**CITY OF PROVIDENCE**  
**BUILDING BOARD OF REVIEW**

Petition for variation or modification of the application of certain provisions of the Rhode Island State Building Code:

PROJECT :  
CONVERSION OF EXISTING 2-FAMILY DWELLING TO  
PROPOSED 3-FAMILY DWELLING  
427-429 LLOYD AVENUE  
PROVIDENCE, R.I. 02906

NOTICE OF REFUSAL  OF PERMIT APPLICATION	CITY OF PROVIDENCE DEPT OF INSPECTIONS AND STANDARDS 444 Westminster Street -Providence, RI. 02903 Joseph A. Doorley – Municipal Building		APPLICATION DATE 9/10/2025	APPLICATION NO. BLDG-25-1244
			DATE OF REFUSAL 10/30/2025	A P P E A L F E E \$440
LOCATION 427 Lloyd Ave. Providence, RI 02906		PAGE NUMBER 1 of 1		
APPLICANT Peter Casale	TITLE Applicant	ADDRESS 250 Gano St. Suite 1, Providence, RI 02906		
PROPERTY OWNER'S NAME Jessie Kerr and Alan Kerr		PROPERTY OWNER'S FULL ADDRESS 427 Lloyd Ave. Providence, RI 02906		
THE APPLICATION FOR A <b>CERTIFICATE OF OCCUPANCY</b> FOR THE ABOVE LOCATION HAS BEEN REFUSED BECAUSE THE PROVISIONS OF THE RHODE ISLAND STATE CODE HAVE NOT BEEN COMPLIED WITH IN THE FOLLOWING PARTICULARS.				
<b>SCOPE OF PERMIT:</b> For interior alteration to change use from two-family dwelling to three-family dwelling.

REAR STAIRS :  
8" RISERS, 9" TREADS  
w/ WINDERS  
INSTALL CONTINUOUS 1.5" DIA.  
WOOD HANDRAIL AT ONE SIDE  
OF EXISTING STAIRS - 34"-36"  
HGT. TO TOP OF HANDRAIL  
FROM ALL STAIR NOSINGS

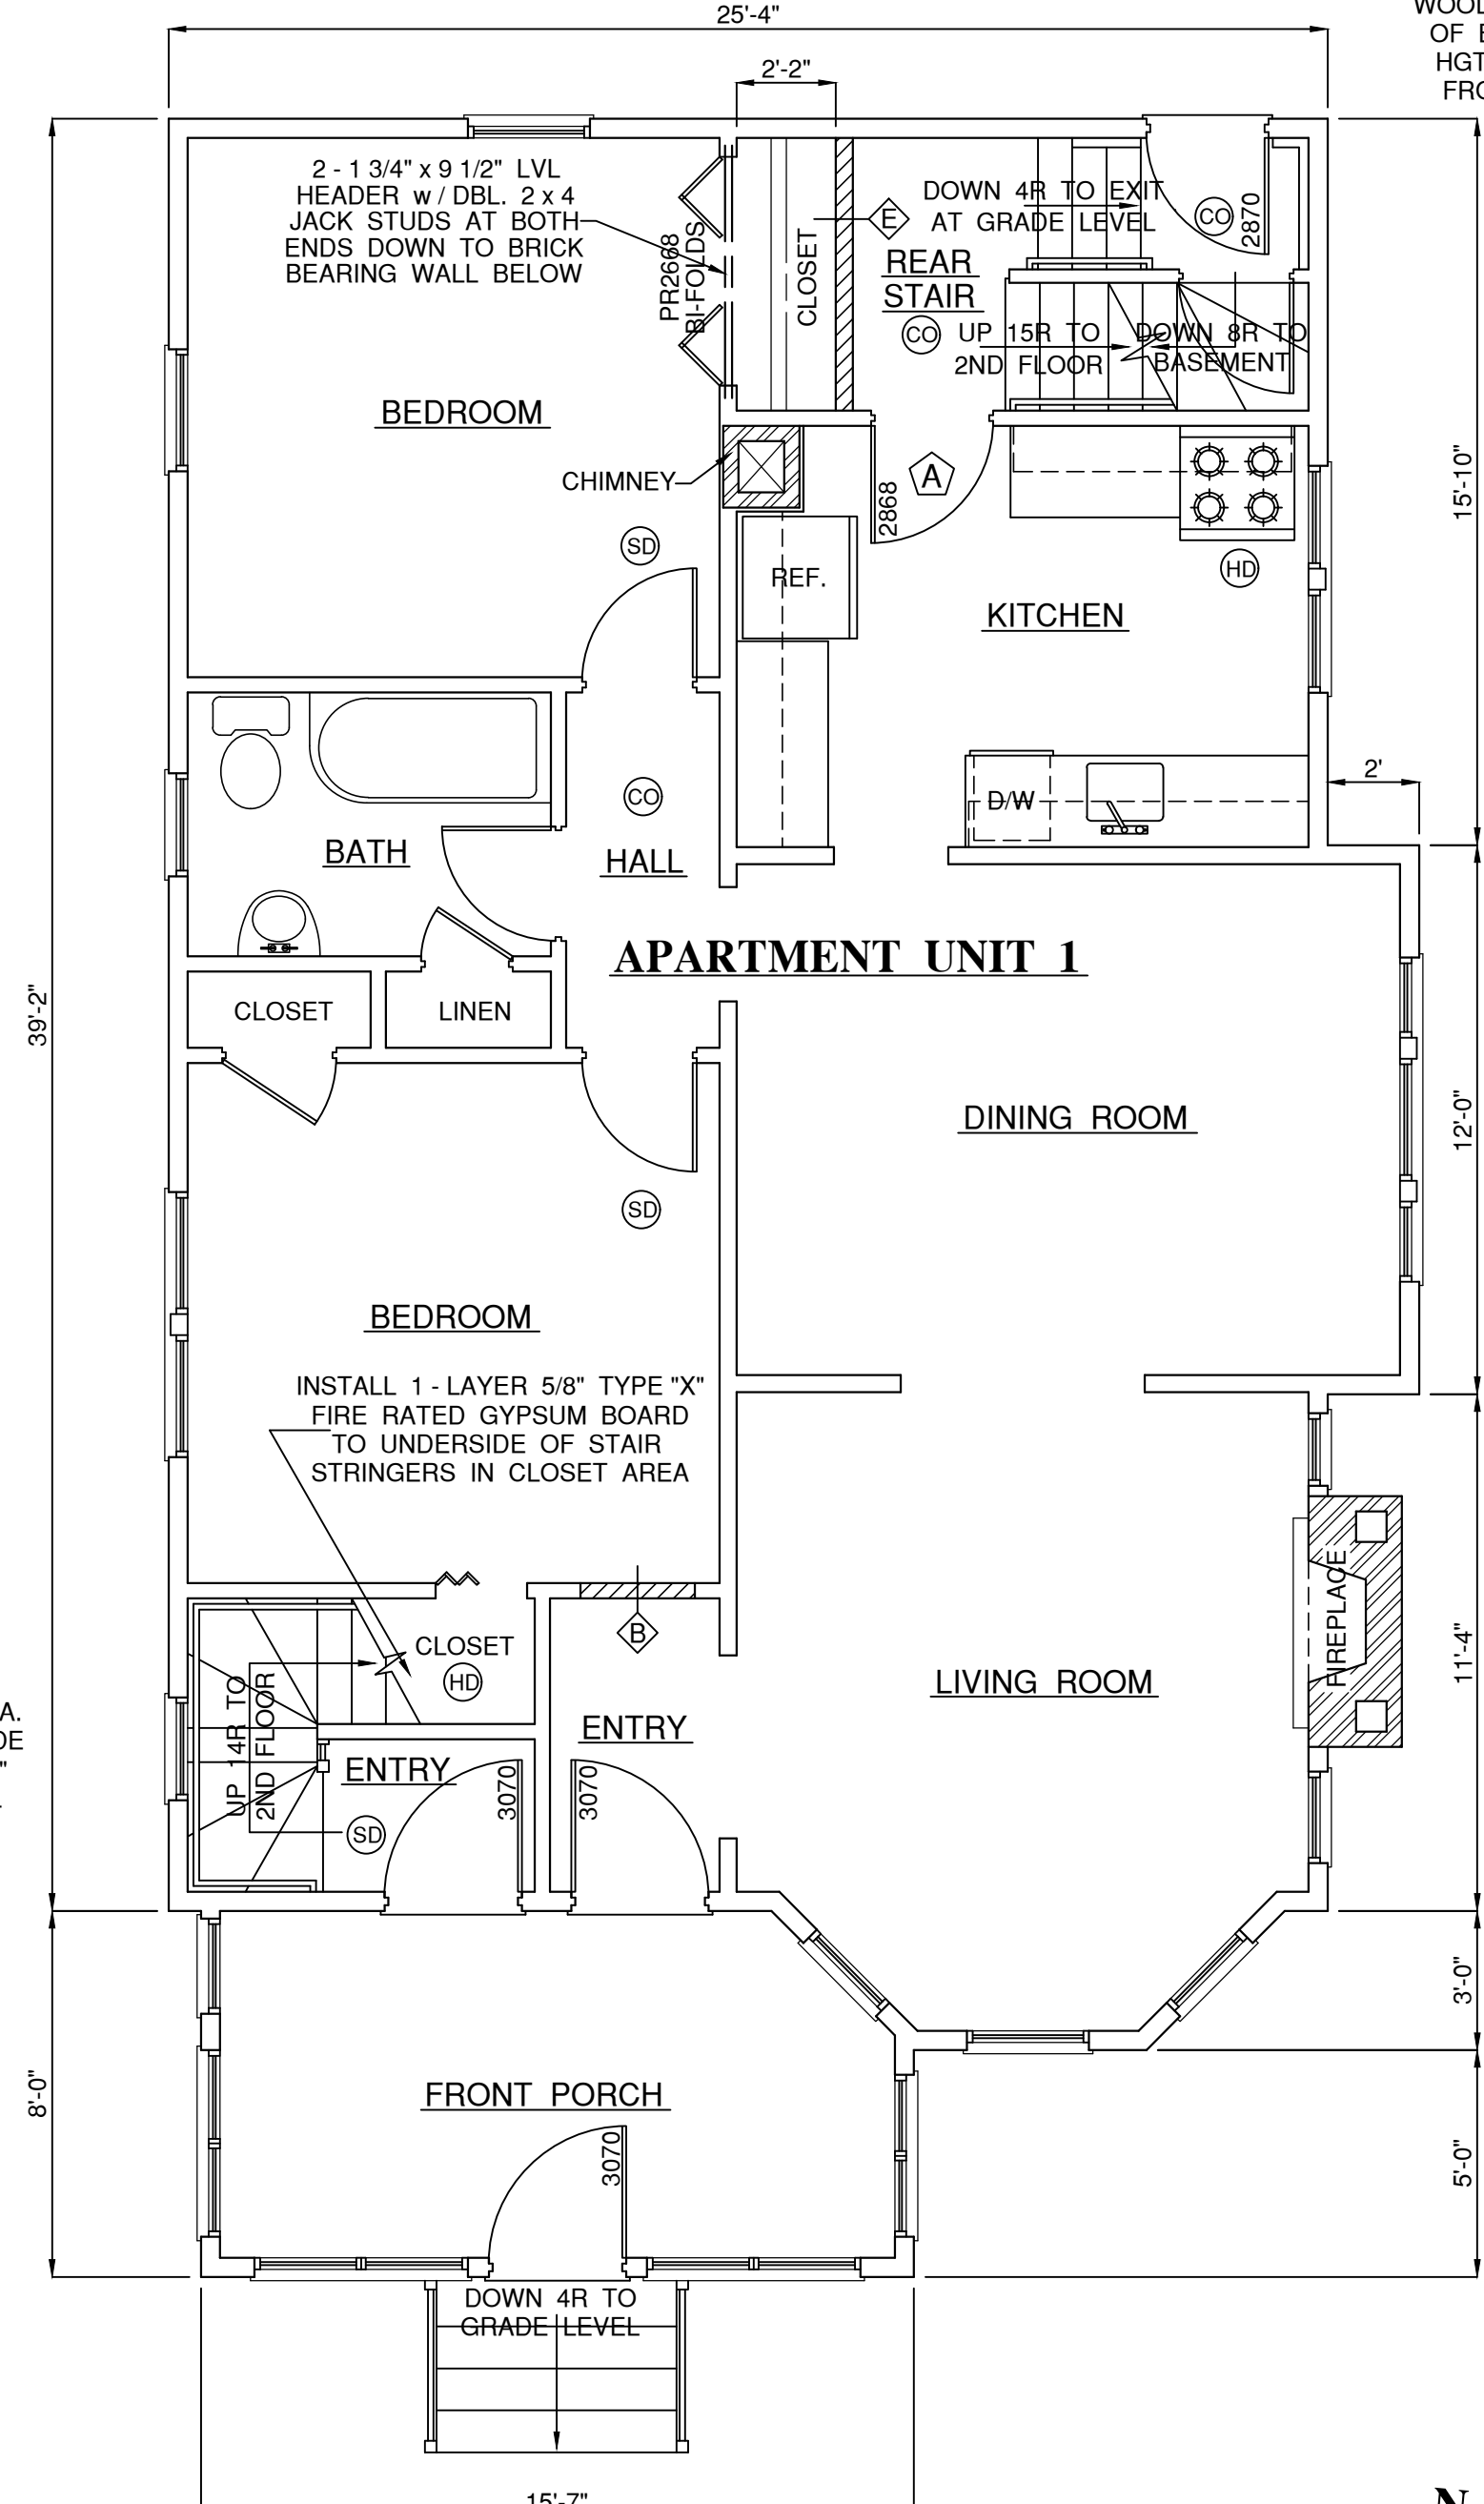
Has the proposed scope of work been completed? <input type="radio"/> Yes <input checked="" type="radio"/> No    Has a violation been noted for this property? <input type="radio"/> Yes <input checked="" type="radio"/> No				
<b>RISBC-1 Rhode Island Building Code (510-RICR-00-00-1)</b>		<b>CODE SECTIONS AND REASONS FOR REFUSAL</b>		
Section 3404.1		Alterations Except as provided by section 3401.4 or this section, alterations to any building or structure shall comply with the requirements of the code for new construction. Alterations shall be such that the existing building or structure is no less complying with the provisions of this code than the existing building or structure was prior to the alteration.		
Section 420.4		Automatic sprinkler system. Group R occupancies shall be equipped throughout with an automatic sprinkler system in accordance with Section 903.2.8.		
Section 903.2.8		Group R. An automatic sprinkler system installed in accordance with Section 903.3 shall be provided throughout all buildings with a Group R fire area.

**		Whereas, No fire suppression system is proposed.		
Section 1011.5.2		Riser height and tread depth. Stair riser heights shall be 7 inches (178 mm) maximum.

**		Whereas, the proposed risers are 8 inches.		
Section 1011.5.2		Riser height and tread depth. Rectangular tread depths shall be 11 inches (279 mm) minimum.

**		Whereas, the proposed treads are 9 inches.		
Section 1011.3		Headroom. Stairways shall have a headroom clearance of not less than 80 inches (2032 mm) measured vertically from a line connecting the edge of the nosings.

**		Whereas, the proposed headroom is 64.5/66.5 inches.
